Technical Bulletin

Accessory drive on Renault 1.5 DCi engines

GATES REFERENCE :	Accessory drive	
MAKE :	RENAULT	
MODEL :	Clio II, Express, Kangoo, Rapid, Symbol	
MOTOR :	1.5 dCi	
MOTOR CODE :	K9K700, K9K702, K9K710

Fig.1

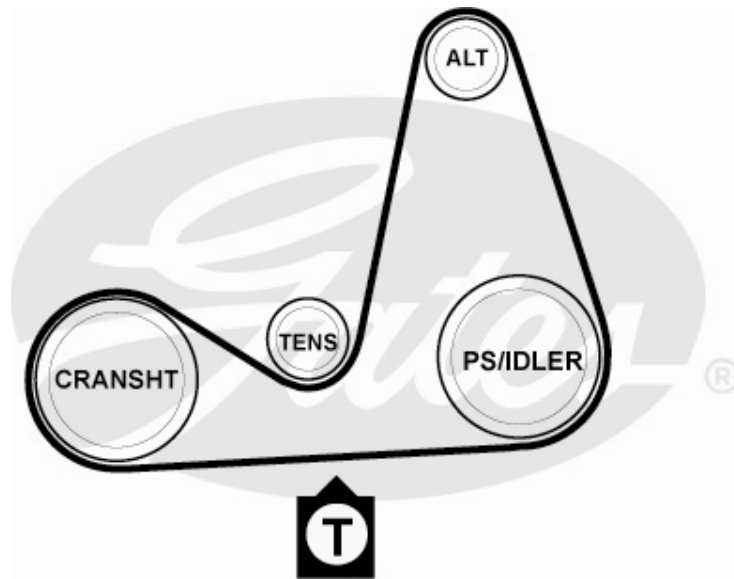
Measure the tension in the bottom span, between the crankshaft and power steering pump (or idler for cars without power steering) (Fig.1).

When measuring the belt tension with the STT-1, key in "8", "180" (virtual span of 180 mm). When measuring with the Krikit[®], tension has to be 70 Kg.

Now tighten the 2 bolts (36 Nm).
Rotate the engine 2 revolutions clockwise.

Check the tension and adjust if needed.
Re-install all removed parts.
